**Community Environmental Response  
Facilitation Act (CERFA) Report  
Fort Wingate Depot Activity  
Gallup, New Mexico**

**U.S. Army Environmental Center  
Response to Regulatory Comments  
Fort Wingate Depot Activity Draft CERFA Report**

**U.S. Army Environmental Center  
Response to Internal Army Comments (Requested by the State of New Mexico Environment Department)  
Fort Wingate Army Depot Activity Draft CERFA Report**

(P)

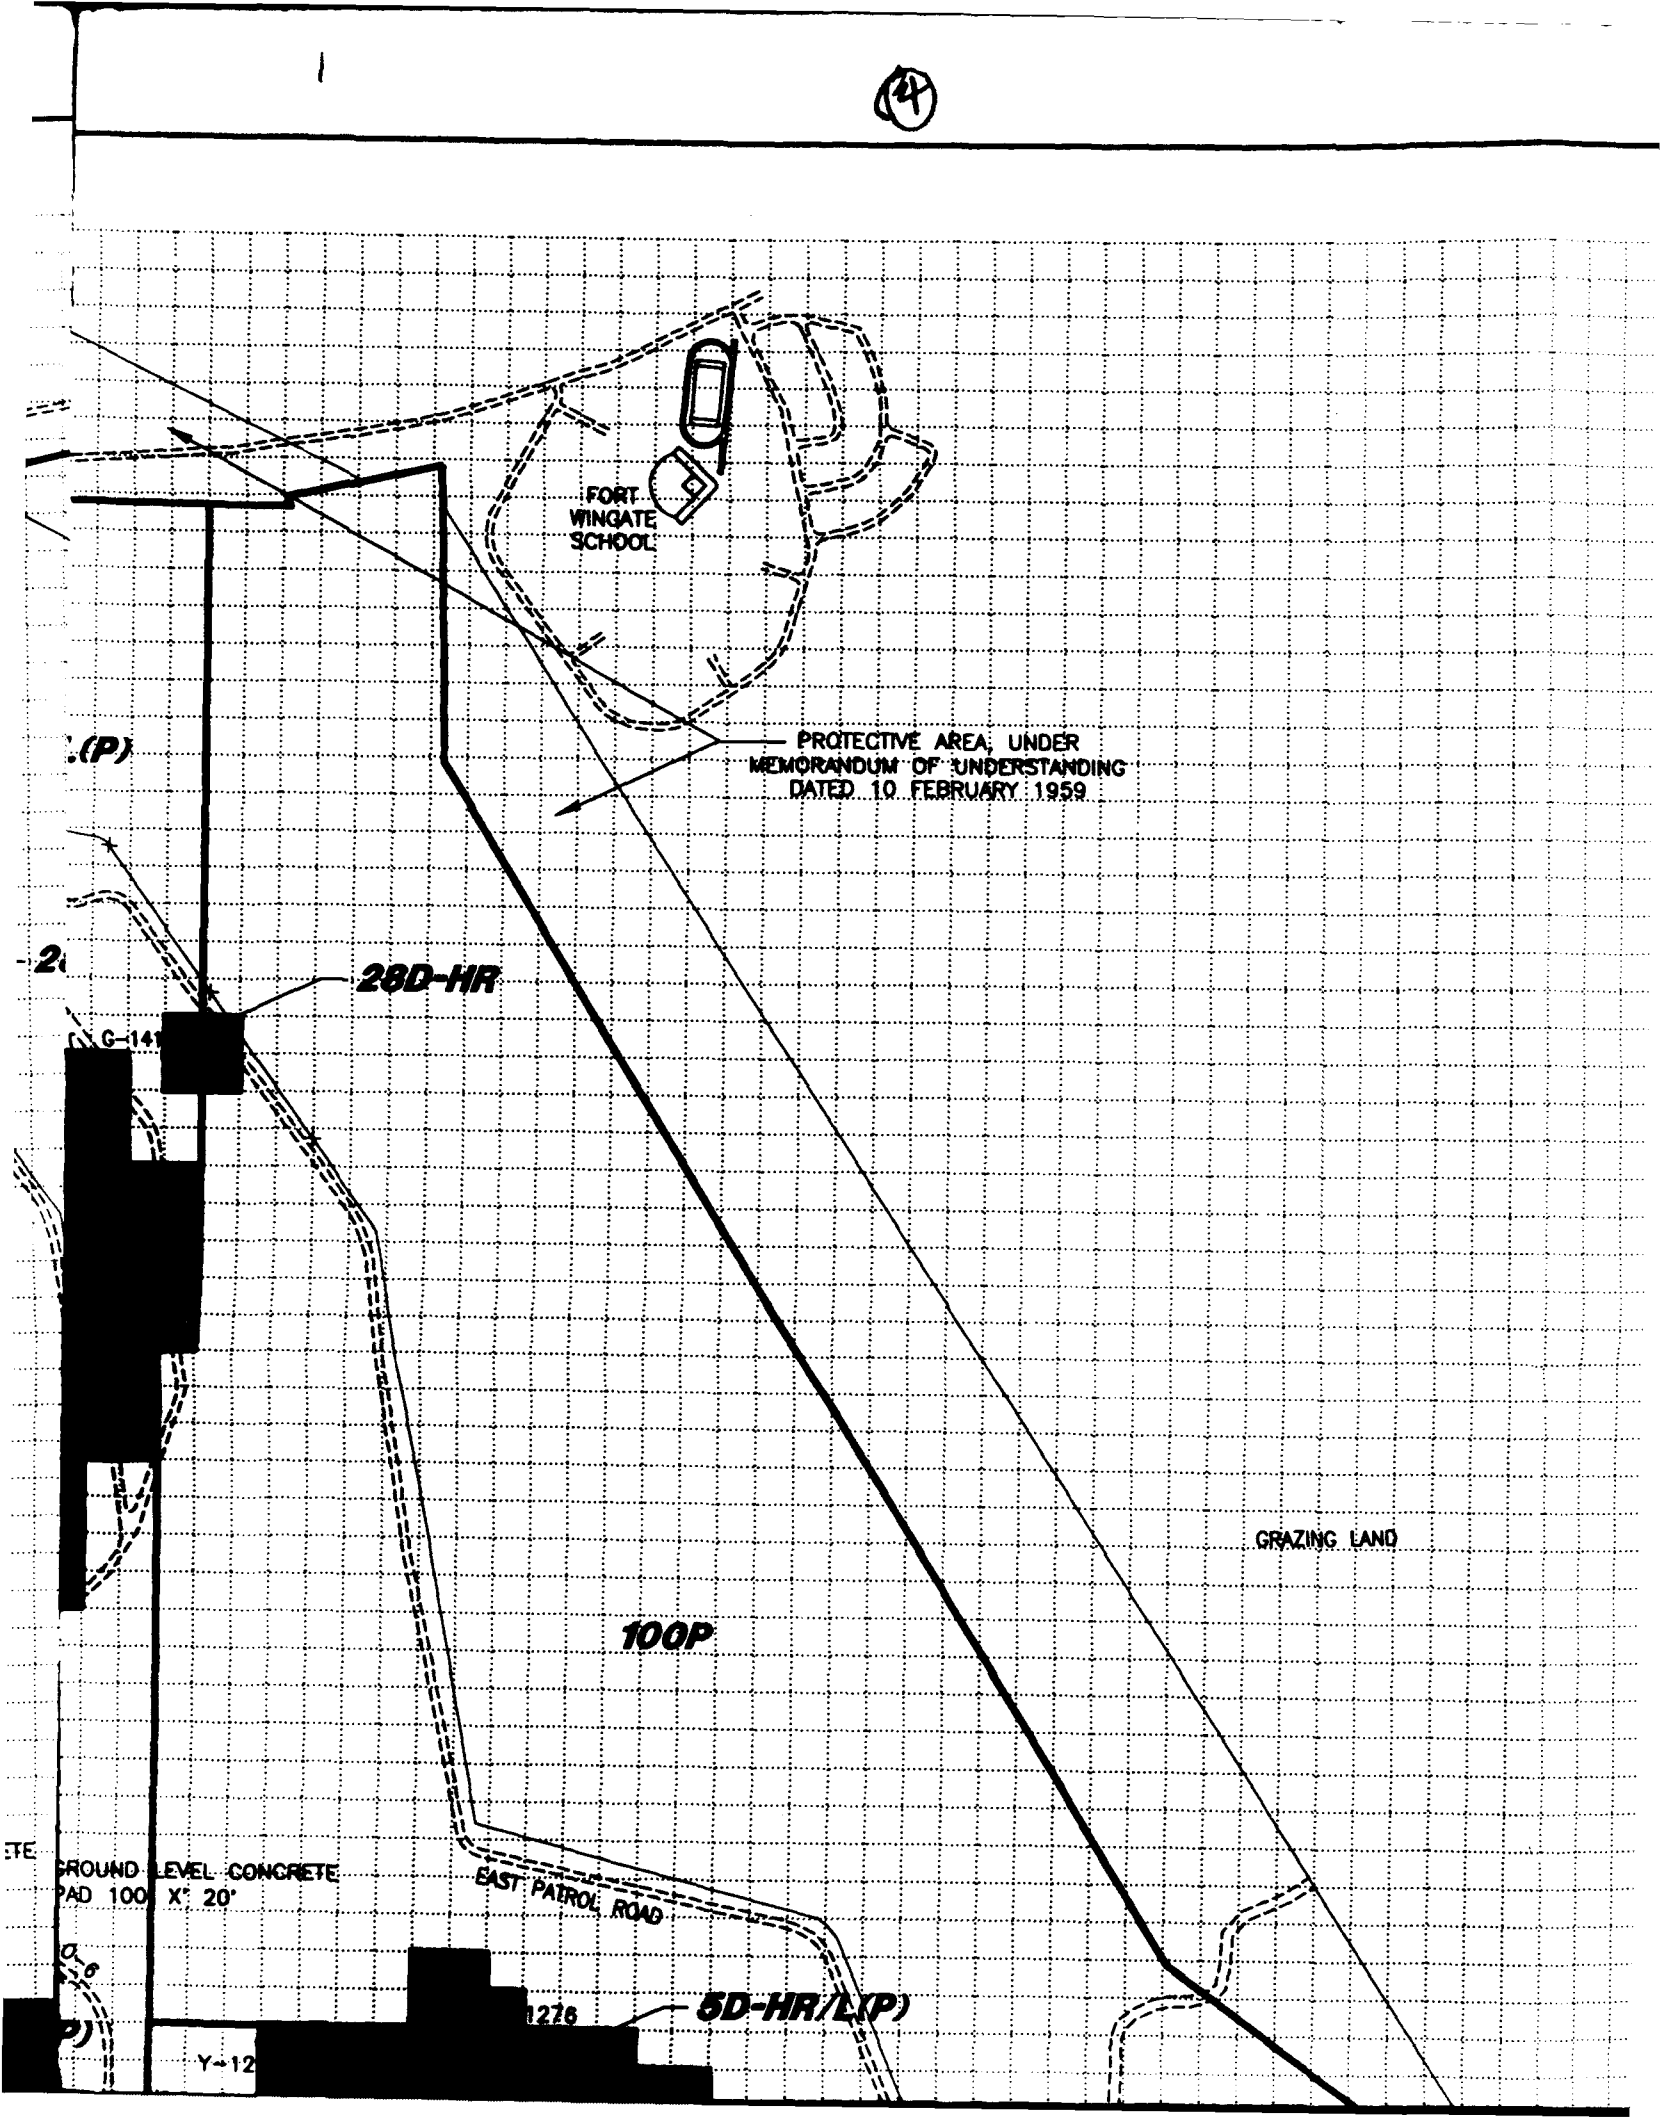
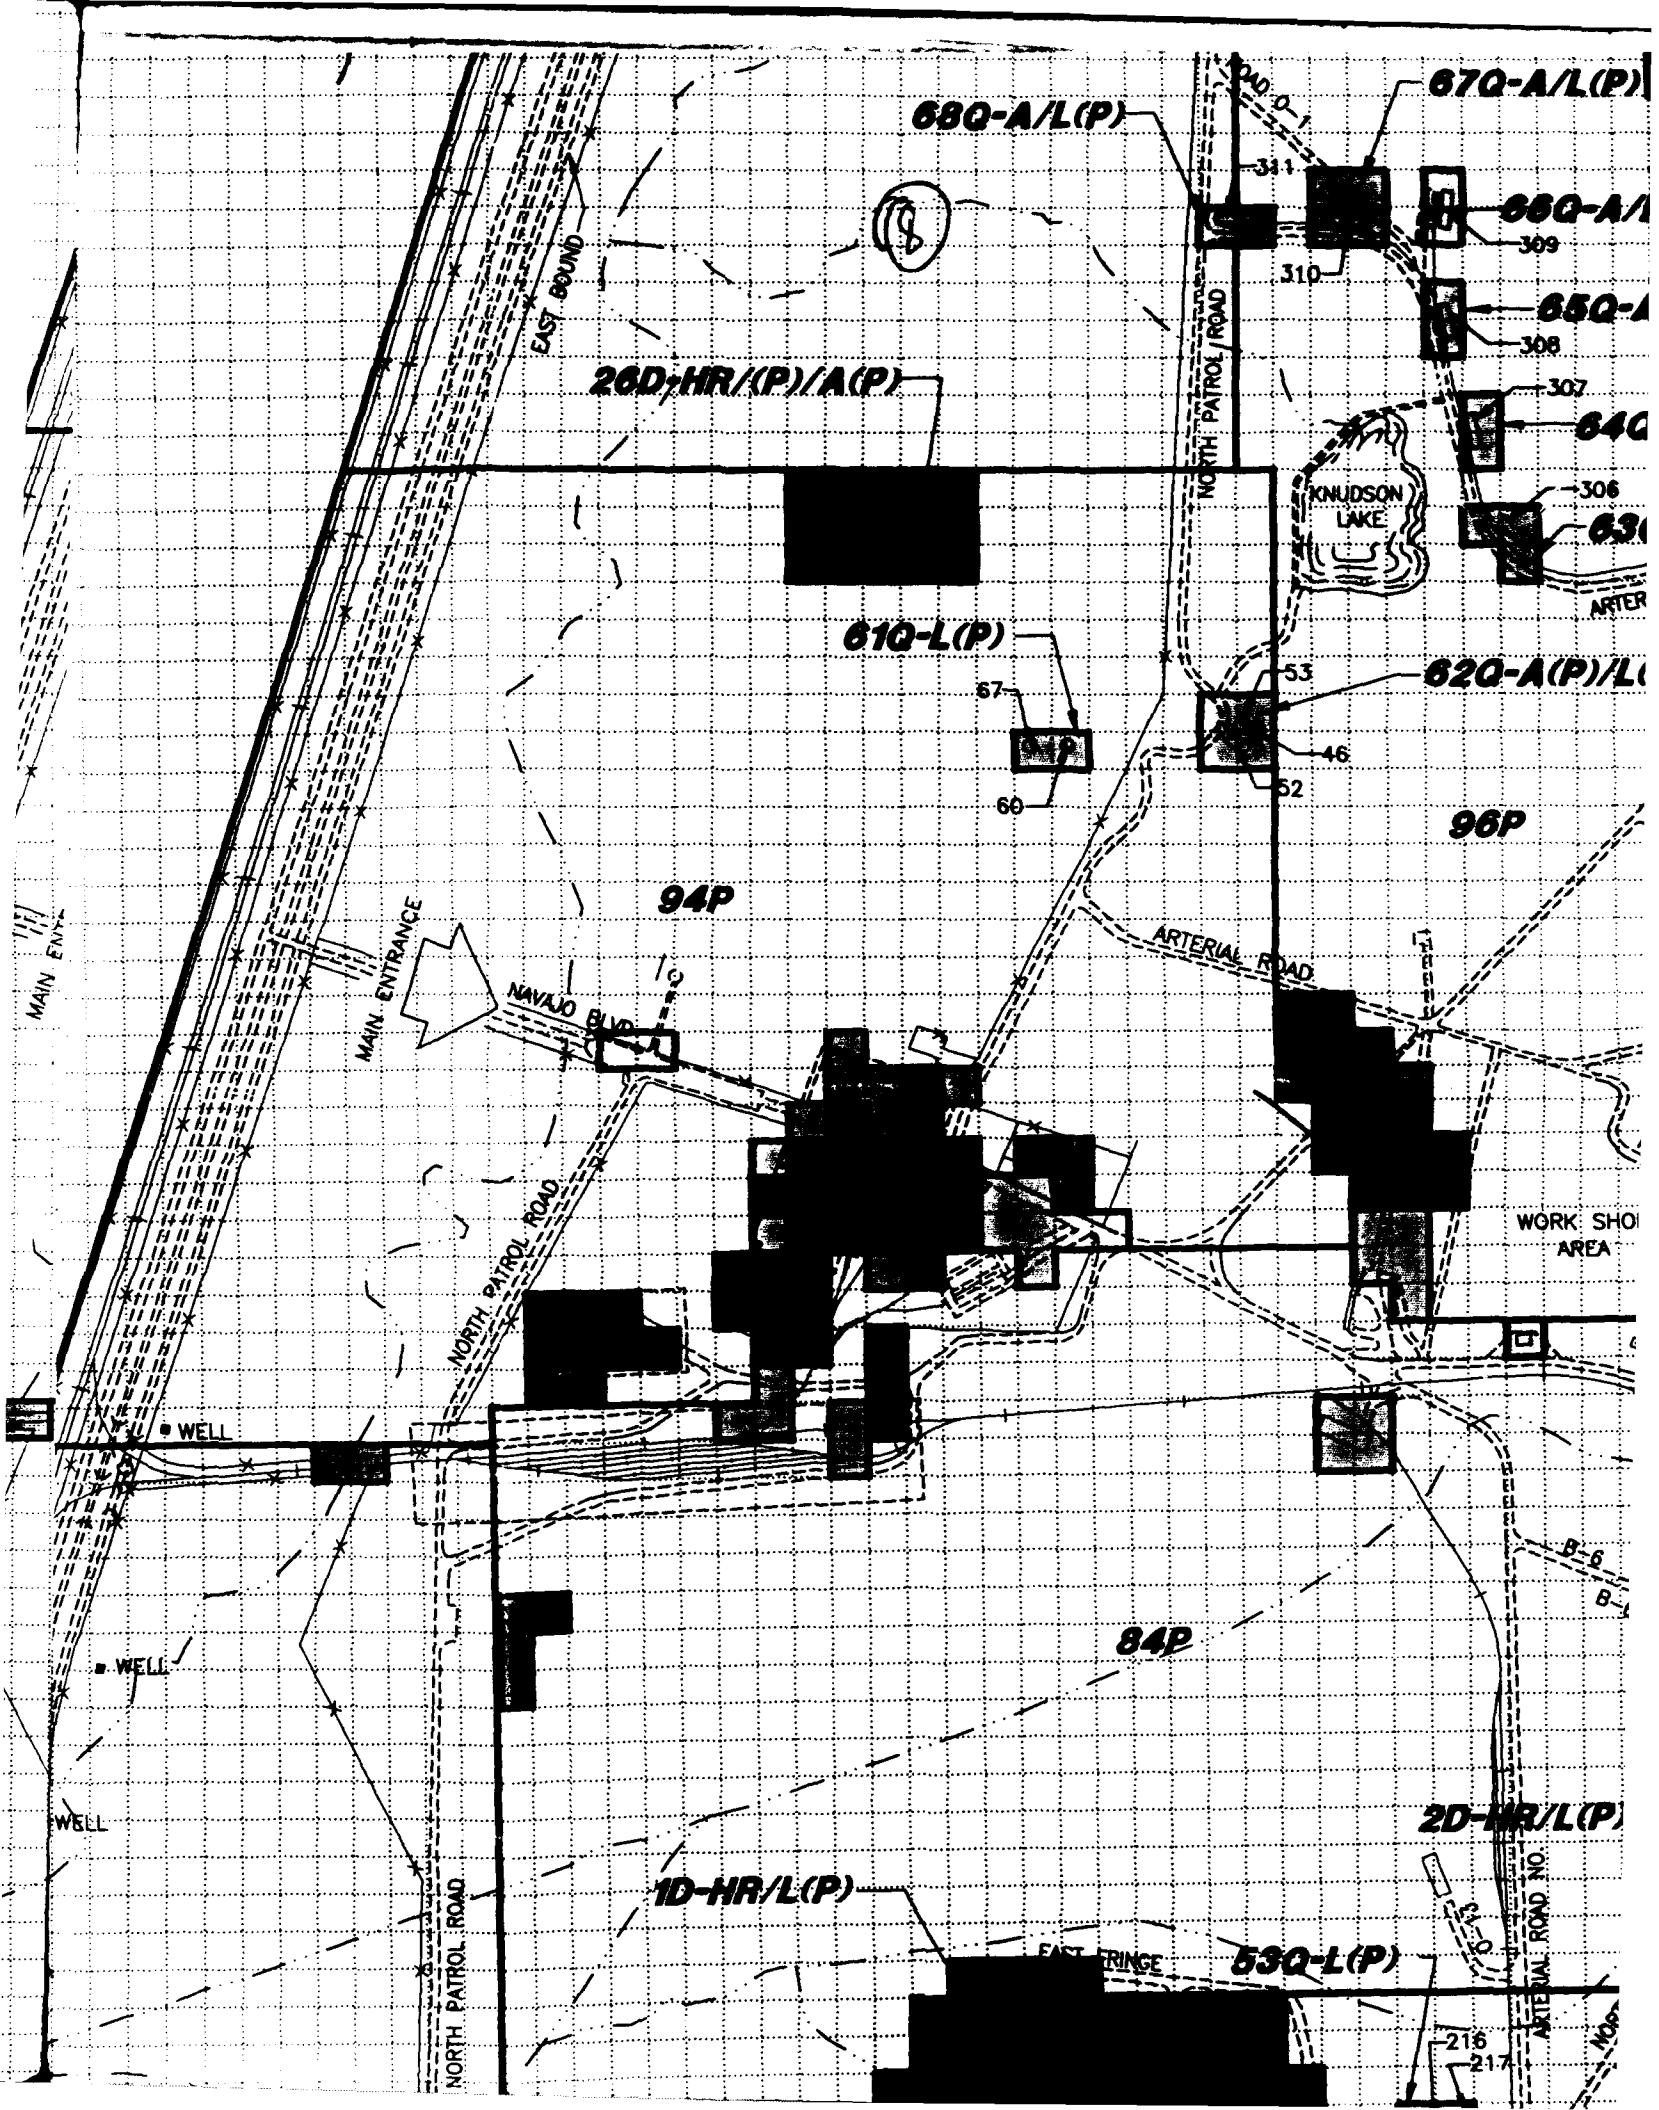
Comment: All maps provided as Figure 5.1-1 should be peer reviewed and approved with the appropriate signature sign off provided in the QA/QC block.

Recommendation: Revise the Figure 5.1-1 maps in accordance with the provided comment.
